APPLICATION NO.	FILING DATE	FIRST NAMED INVENTOR	ATTORNEY DOCKET NO.	CONFIRMATION NO.
10/776,522	02/12/2004	Yohei Makuta	0505-1268P	4129
2292 7590 01/25/2010 BIRCH STEWART KOLASCH & BIRCH PO BOX 747 FALLS CHURCH, VA 22040-0747				
EXAMINER				
GEBREMICHAEL, BRUK A				
ART UNIT		PAPER NUMBER		
3715				
NOTIFICATION DATE		DELIVERY MODE		
01/25/2010		ELECTRONIC

### Office Action Summary

### DETAILED ACTION

FIG 1 of Ritchie Patent (US 4,837,605)

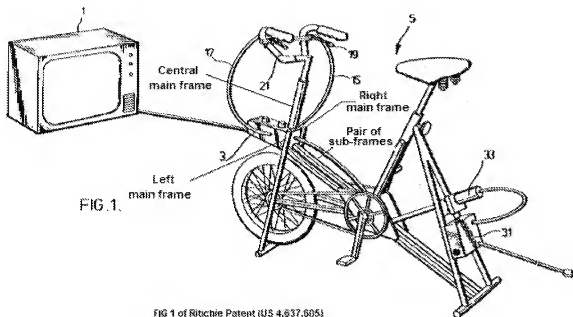
However, Ritchie teaches, a pair of left and right main frames, a centrally located main frame a pair of sub-frames connected to roughly central portions of the right and left main frames (see Examiner's annotated figure, FIG A which is based on FIG 1 of Ritchie's apparatus, label Pair of sub-frames), and a control unit for the system being mounted in a position between linear portions of the pair of left and right main frames and under the centrally located main frame (see FIG 1, label 3 and also see FIG A regarding the Examiner's interpretation).

It is also very apparent from the teaching of the prior art that the control unit (e.g. see Ritchie, FIG 1, label 3) is positioned between the left and right main frames, and under the centrally located main frame (see FIG A below regarding the frames identified by the Examiner) in such a way that it does not restrict the field of vision of the operator.

However, Ritchie teaches, a pair of left and right main frames, a centrally located main frame a pair of sub-frames connected to roughly central portions of the right and left main frames (see Examiner's annotated figure, FIG A which is based on FIG 1 of Ritchie's apparatus, label Pair of sub-frames), and a control unit for the system being

arrangement between the *left and right main frames* and the *steering stem* is critical to the current invention (or solves any stated problem); The prior art teaches a left and right main frames supporting the steering stem of the simulator (see FIG A below) so that the user operates the simulator as a realistic motorbike. Therefore, the system of the prior art appears to work well for the intended purpose.

Ritchie further teaches, the end of the centrally located main frame is connected to a cross frame bridging between tip end portions of the sub-frames (see FIG A, the section i.e. wall of the control unit where the end of the pair of sub- frames and end of the central frame are connected).

Regarding claims 20 and 21, Caprai in view of Ritchie teaches the claimed limitations as discussed above. Ritchie further teaches, a cylinder portion for receiving a steering stem, and wherein each of the right, left, and centrally located main frames has an upper end connected to the cylindrical portion (see FIG A below with the examiner's interpretation, the central frame, and the left and right main frames).

Regarding the Ritchie reference, as can be seen in the Examiner's annotated FIG 1, a major portion of control box 3 is located above the pair of pipes which the Examiner refers to as "pair of sub-frames". Thus, Ritchie cannot make up for the deficiency of Caprai to reject independent claim 1.

As can be seen in the Examiner's Ritchie annotated FIG 1, the elements referred to by the Examiner as "central main frame" and "left and right main frames" are parallel

Applicant further argues the "central main frame" and "left and right main frames" are in parallel to each other according to Ritchie's system. Although one may not certainly conclude such parallel arrangement solely from the figures of the prior art, here also the focus of the argument appears to be on the arrangements of the structures of the device. Note that the functional limitation of the left and right main frames (FIG 2, labels 52b and 52a) appears to be to support the cylindrical portion (FIG 2, label 44) of the simulator, and also to support the control unit between the frames, and to attach the device on a table. These functional limitations have already been taught or suggested by the prior art (see *Claim Rejections - 35 USC § 103* above for detail analysis). In addition, Applicant's disclosure as originally filed (e.g. see Para.0034 of originally filed application) does not disclose any importance as to why such acute angle arrangement between the *left and right main frames* and the *steering stem* is critical to the current invention (or solves any stated problem); and therefore, the system of the prior art appears to work well for the intended purpose.
